Number: SB 2X-77-04 R1
Issued: August 16, 2012
Revised: May 8, 2013

SNS SUBJECT: 77-00 ENGINE INDICATING - MAP / Oil Pressure Sensor Replacement

On affected aircraft, the MAP / oil pressure sensors may experience strain at the connector terminations where signal intermittences could occur. To reduce potential erratic indications of MAP or oil pressure, this Service Bulletin provides for the installation of the MAP / Oil Pressure Sensor Replacement kit.

Figure 01
Baffle Modification (1 of 2)

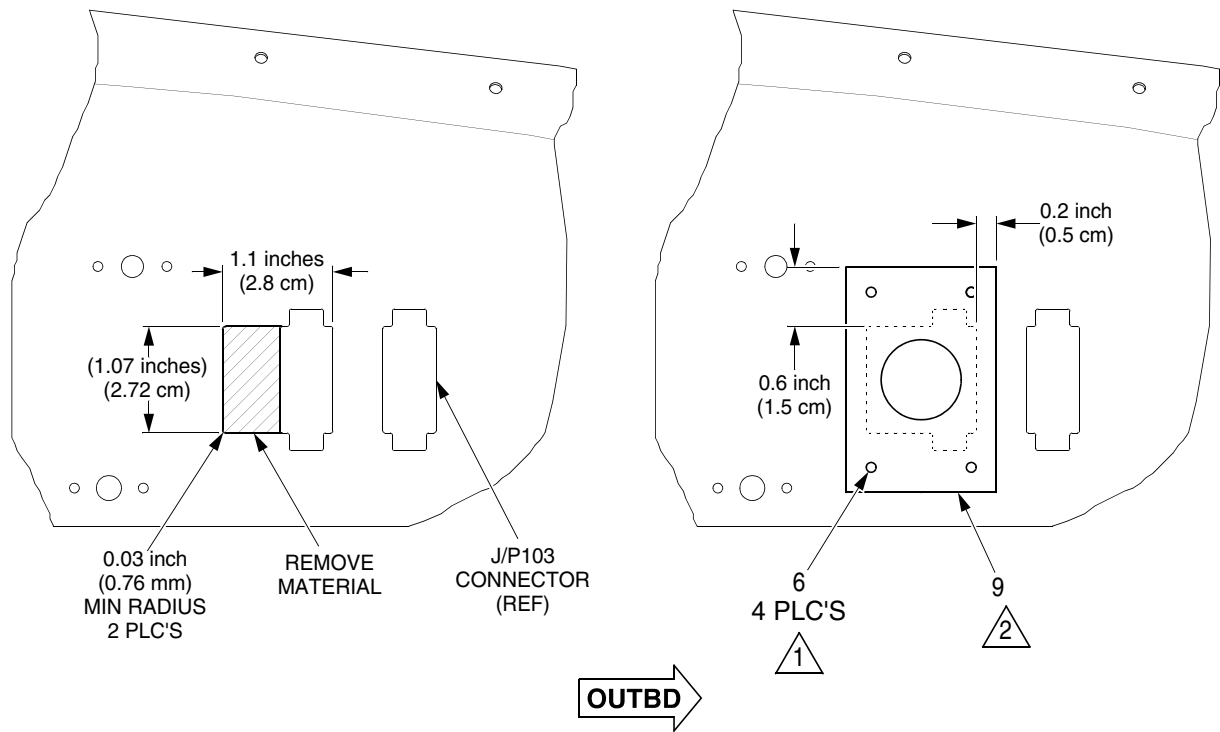
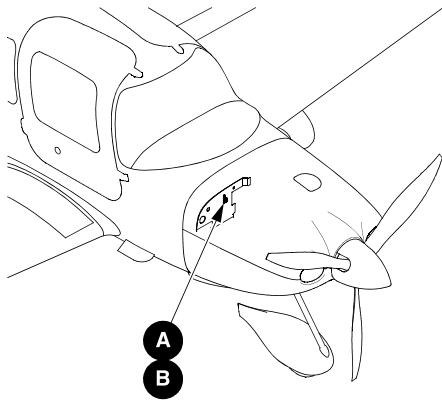
- F. Modify aft baffle. **(See Figure 01)**
- (1) *SR22/SR22T Serials*: Move J/P103 connectors to lower inboard hole of baffle as shown.
 - (2) Trim connector hole in aft right baffle.

- (a) At aft side of aft right baffle, measure cut-out area.
 - 1 *SR20 Serials*: From RH edge of inboard connector opening, measure 1.1 inches (27.9 mm) to left and mark vertical line.

- 2 *SR22 Serials 0002 thru 0277*: From LH edge of outboard upper connector opening, measure 1.2 inches (30.5 mm) to right and mark vertical line.
 - 3 *SR22 Serials 0278 thru 3849*: From RH edge of upper connector opening, measure 1.1 inches (27.9 mm) to left and mark vertical line.

- 4 *SR22T Serials*: From RH edge of upper connector opening, measure 1.1 inches (27.9 mm) to left and mark vertical line.
 - 5 From upper and lower offset corners, mark horizontal lines to intersect with vertical line.

- (b) Using rotary power tool with carbide disc, cut outlined region from baffle assembly.
 - (c) Solvent clean trimmed edges of baffle assembly. (Refer to AMM 20-30)

- (d) Apply Alodine to abraded surfaces of baffle assembly.
 - (3) Install plate.
 - (a) *SR22 and SR22T Serials w/ black anodized baffle*: Discard plate (29629-002), use black plate (29629-003).

- (c) *SR20 Serials*: Position plate on aft baffle over connector hole so that cut-out is centered (0.6 inch from upper cut-out to upper edge of plate, 0.2 inch from RH cut-out edge to RH edge of plate).

- NOTE**
- ① Using 0.098-inch drill bit, drill rivet holes in baffle.
 - ② Position doubler plate to aft side of baffle and secure with rivets.

Figure 01
Baffle Modification (2 of 2)

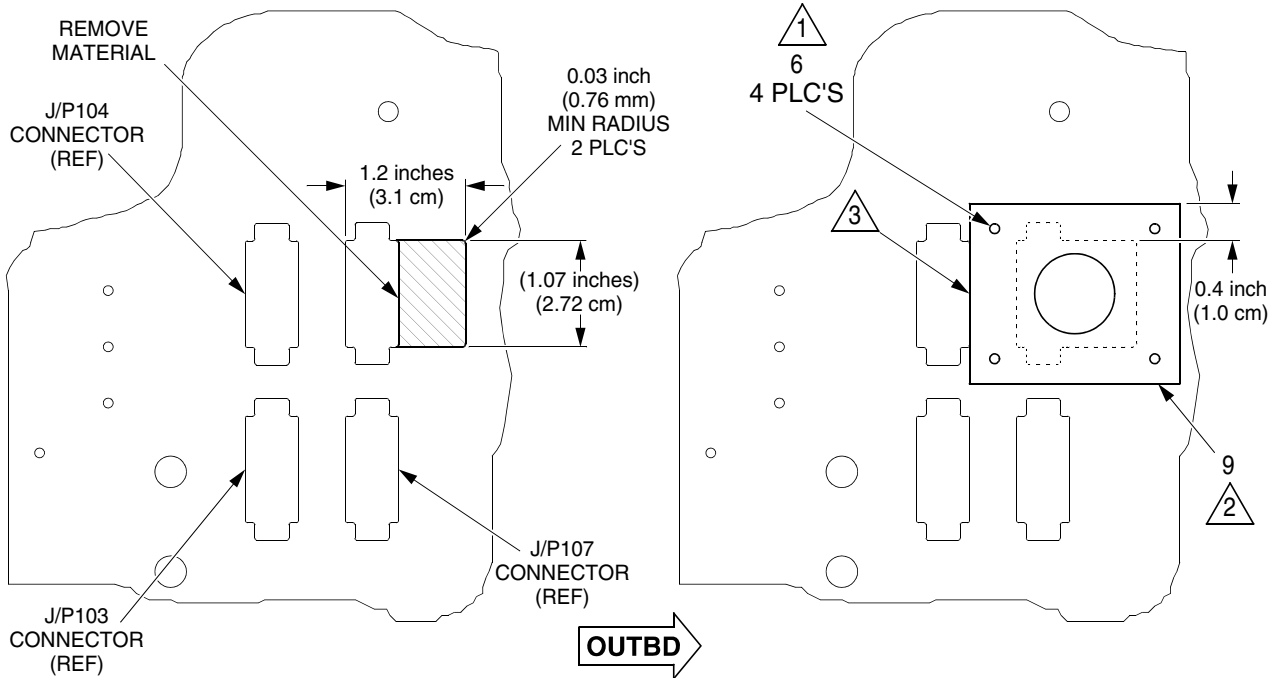
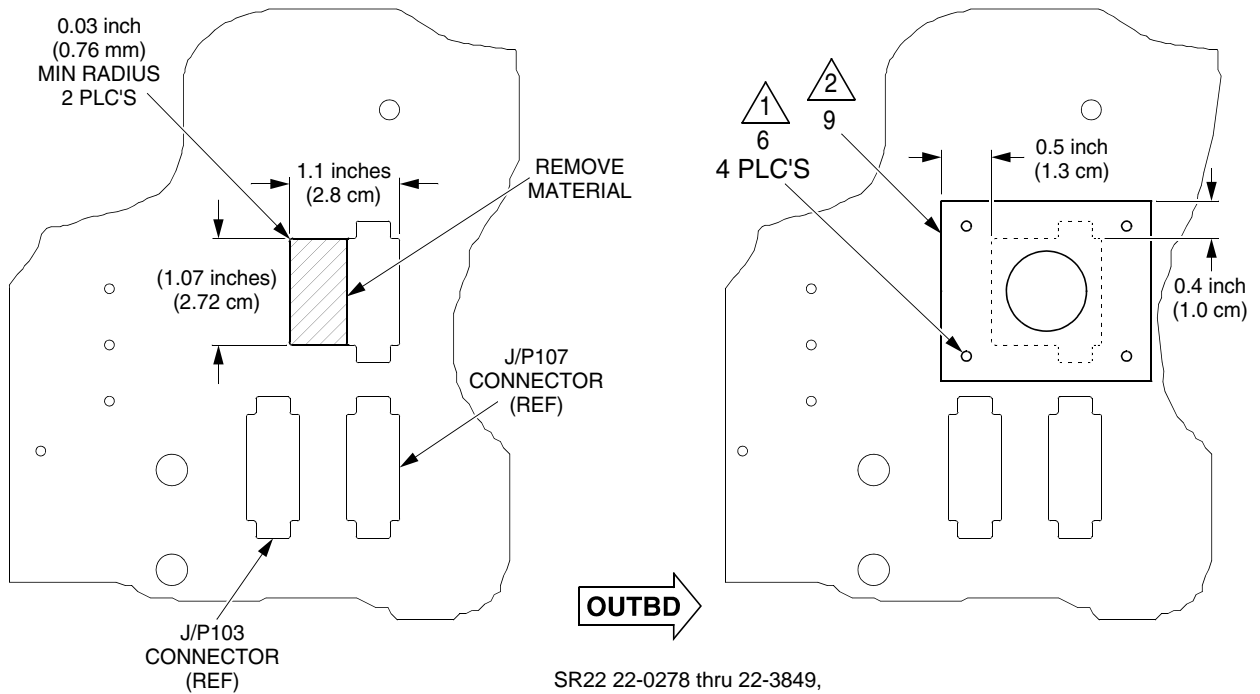
- (b) *SR22 Serials 0002 thru 0277*: Position plate on aft baffle over connector hole so that cut-out is centered (0.4 inch from upper cut-out to upper edge of plate, LH edge of plate aligned with RH edge of inboard upper connector hole within +0.1/-0.0 inch).

- (d) *SR22 Serials 0278 thru 3849, & SR22T Serials*: Position plate on aft baffle over connector hole so that cut-out is centered (0.4 inch from upper cut-out to upper edge of plate, 0.5 inch from LH cut-out edge to LH edge of plate).

- 1 Using 0.098-inch drill bit, drill rivet holes in baffle.
- 2 Position doubler plate to aft side of baffle and secure with rivets.
- 3 Align plate with this edge +0.1 / -0.0 (+2.5 / -0.0 cm)

**Figure 02
 Oil Pressure/ MAP Sensor Harness Modification**

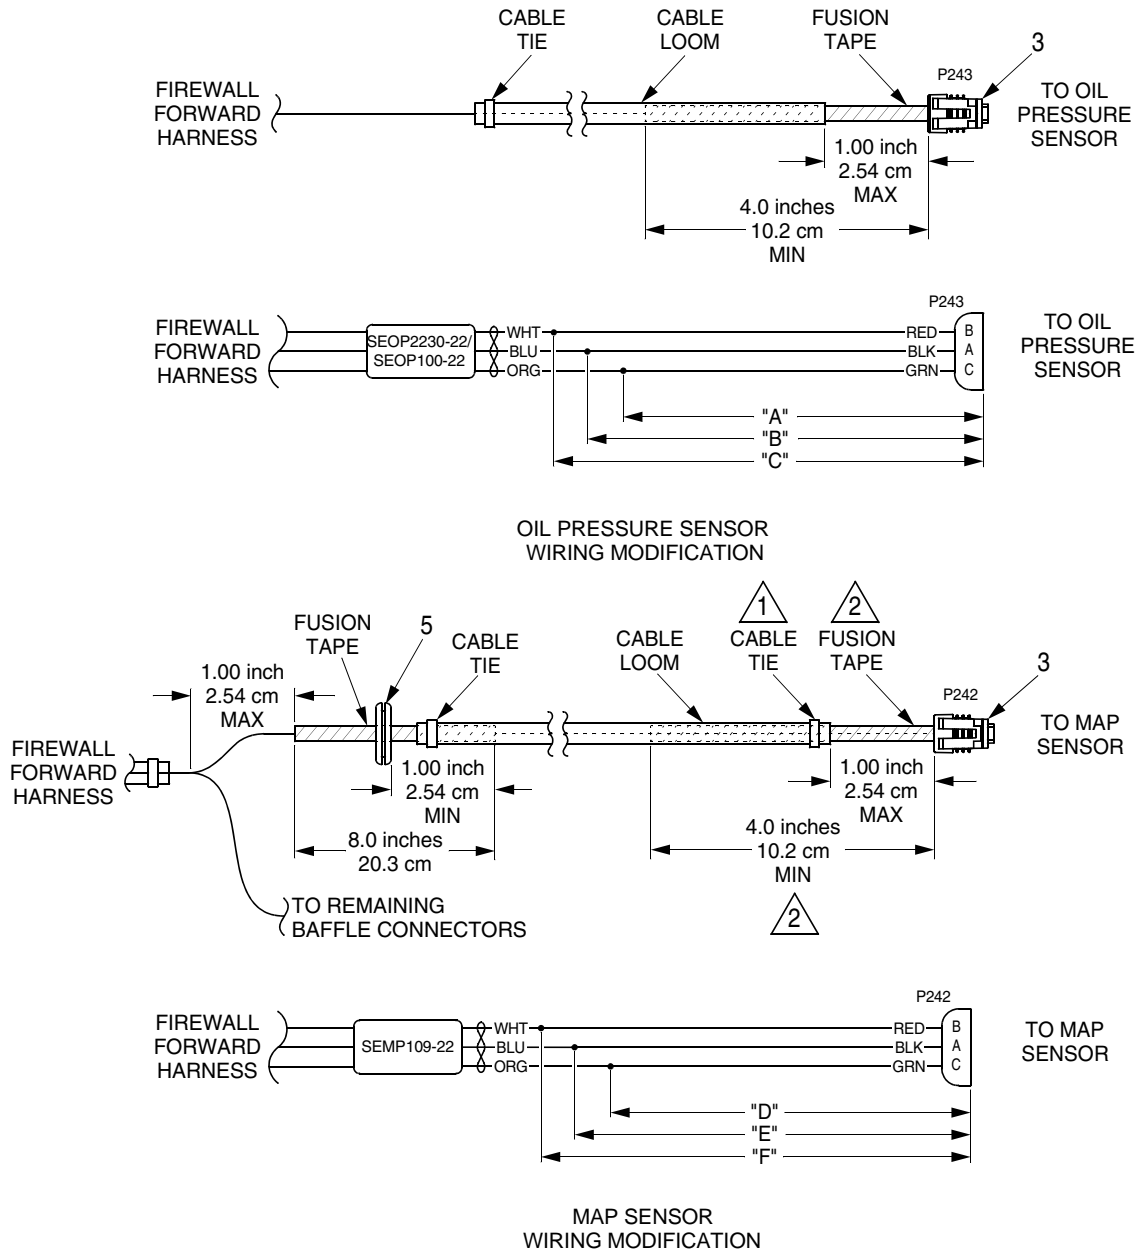
K. Replace oil pressure sensor connector. (Refer to WM 20-10) **(See Figure 02)**

- (1) Disconnect and discard wiring from P101 to oil pressure sensor.
- (2) Remove P101 from firewall forward wire harness. Cut ORG wire at connector; stagger remaining wire cuts away from connector.

- (3) Add pressure sensor connector assembly to SEOP2230-22 (*Serials w/ Perspective Avionics*) or SEOP100-22 (*Serials w/o Perspective Avionics*).

- (4) Wrap wires with fusion tape and cover wire with split, corrugated loom. Ensure that the loom covers all of heat shrink at splice joints. Secure loom with cable ties within 0.5 inch of open ends of loom where indicated and at intervals of 5 - 10 inches along loom.

L. Replace MAP sensor connector. (Refer to WM 20-10) **(See Figure 02)**

- (1) Disconnect and discard wiring from J105 to MAP sensor.
- (2) Remove J105 from firewall forward wire harness. Cut ORG wire at connector; stagger remaining wire cuts away from connector.

- (3) Add pressure sensor connector assembly to SEMP109-22.

- (d) Cover splices with small heat shrink.
(e) Cover splices together with second layer of large heat shrink.
(4) Wrap the wire bundle with fusion tape, position grommet over fusion tape, and install corrugated loom. Secure loom with cable ties within 0.5 inch of open ends of loom where indicated and at intervals of 5 - 10 inches along loom.

- (5) Add connector label to P242 (map sensor connector) using wire marker.
(6) Route connector P242 through hole in connector plate. Install grommet in hole and slide wire through grommet to appropriate position.
(7) Route and connect P242 to MAP sensor.
(8) Secure wiring per standard practices.

Figure 03
Sensor Relief Modification

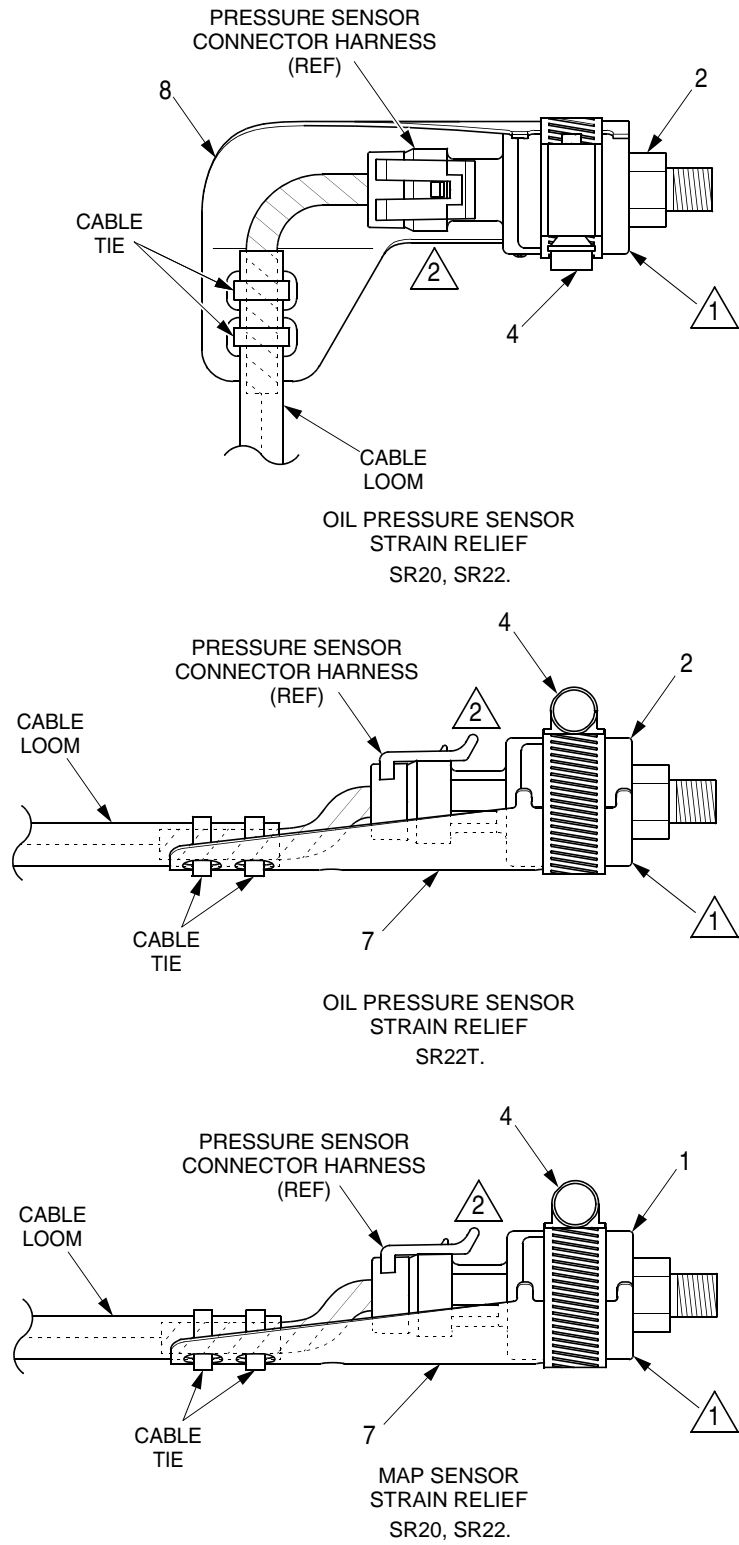
M. Install oil pressure sensor strain relief. **(See Figure 03)**

- (1) Install strain relief onto oil pressure sensor.
(2) Orient strain relief and sensor body on engine as required to ensure appropriate wire routing.

N. *SR20/SR22 Serials:* Install map sensor strain relief. **(See Figure 03)**

- (1) Install strain relief onto MAP sensor.

- NOTE**
- 1 Align sensor with edge of strain relief ± 0.10 inch (± 2.5 cm).
 - 2 Ensure strain relief is oriented opposite connector lock tab.
